**RESOLUTION MSC.222(82)**  
**(adopted on 8 December 2006)**

**AMENDMENTS TO THE INTERNATIONAL CODE  
OF SAFETY FOR HIGH-SPEED CRAFT, 2000  
(2000 HSC CODE)**

**Figure 2.6.7a**

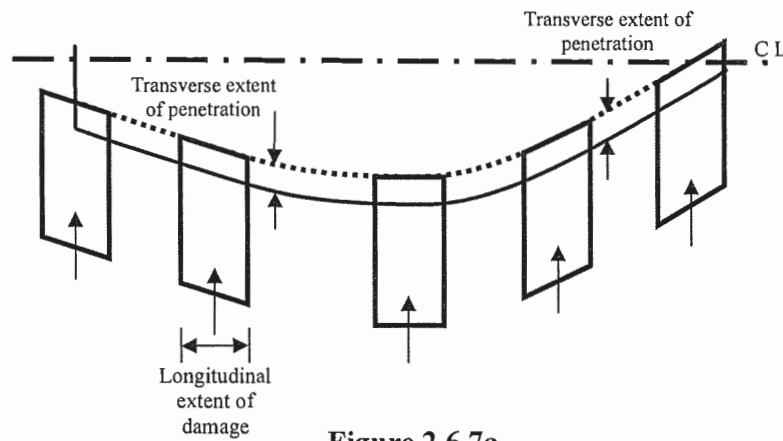
“The damages described in this paragraph shall be assumed to have the shape of a parallelepiped. Applying this to figure 2.6.7a, the inboard face at its mid-length shall be tangential to, or otherwise touching in a least 2 places, the surface corresponding to the specified transverse extent of penetration, as illustrated in figure 2.6.7a.

**Figure 2.6.7b**

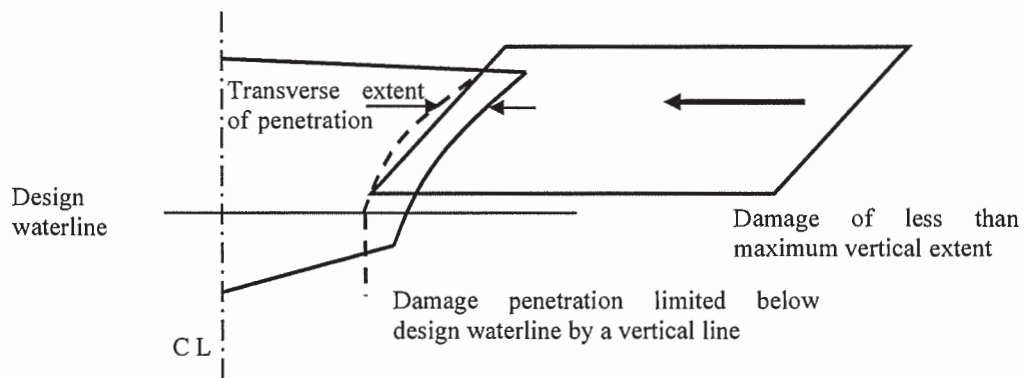
Side damage shall not transversely penetrate a greater distance than the extent of  $0.2\nabla^{1/3}$  at the design waterline, except where a lesser extent is provided for in 2.6.7.2. Refer to figures 2.6.7b and 2.6.7c.

**Figure 2.6.8”**

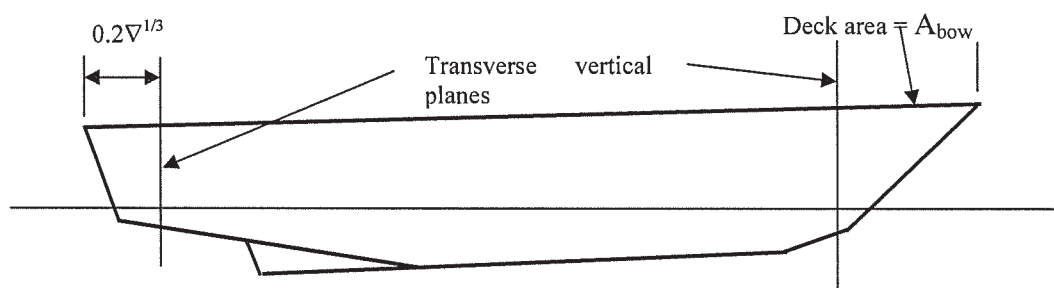
2.6.8.1 The following extents of damage are to be applied to bow and stern, as illustrated in figure 2.6.8:

- .1 at the fore end, damage to the area defined as  $A_{\text{bow}}$  in 4.4.1, the aft limit of which being a transverse vertical plane, provided that this area need not extend further aft from the forward extremity of the craft's watertight envelope than the distance defined in 2.6.7.1; and
- .2 at the aft end, damage to the area aft of a transverse vertical plane at a distance  $0.2\nabla^{1/3}$  forward of the aft extremity of the watertight envelope of the hull.

**Figure 2.6.9.2**

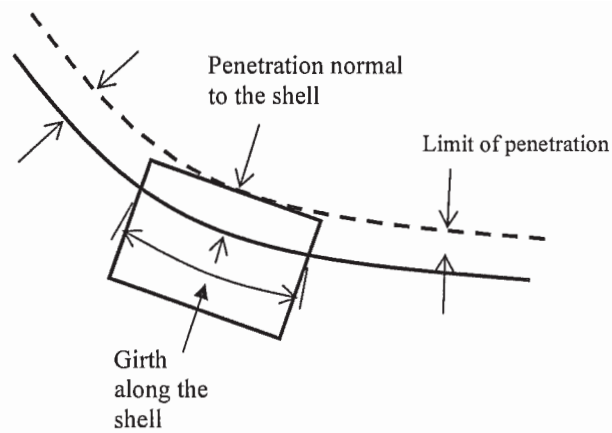
“2.6.9.2.3 The shape of damage shall be assumed to be rectangular in the transverse plane as illustrated in figure 2.6.9.2 below. Damage is to be assumed at a series of sections within the defined longitudinal extent in accordance with figure 2.6.9.2, the mid-point of the damaged girth being maintained at a constant distance from the centreline throughout that longitudinal extent.

“.4 the shape of damage shall be assumed to be rectangular in the plane of the shell of the craft, and rectangular in the transverse plane as illustrated in figure 2.6.9.2.”

Figure 7.3.4a

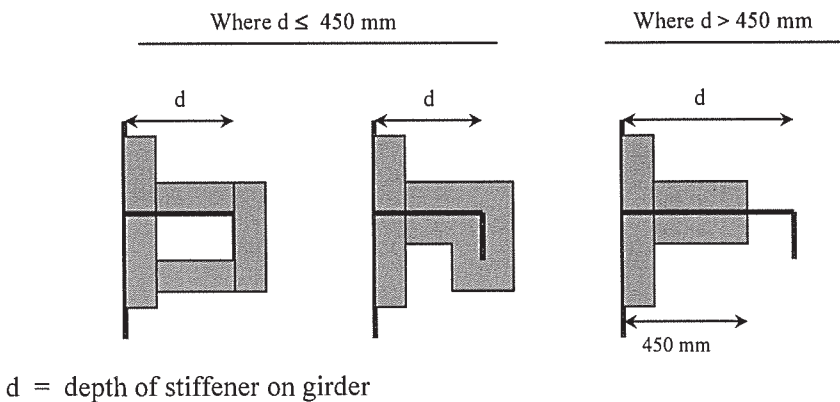
“7.3.4 To prevent heat transmission at intersections and terminal points, the insulation of the deck or bulkhead shall be carried past the intersection or terminal point for a distance of at least 450 mm in the case of steel or aluminium structures (refer to figures 7.3.4a and 7.3.4b).

Figure 7.3.6 "

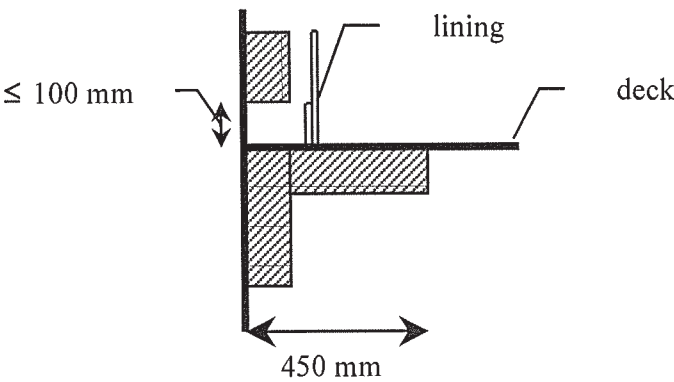
7.3.6 Where the lower part of the fire insulation has to be cut for drainage, the construction shall be in accordance with the structural details shown in figure 7.3.6.
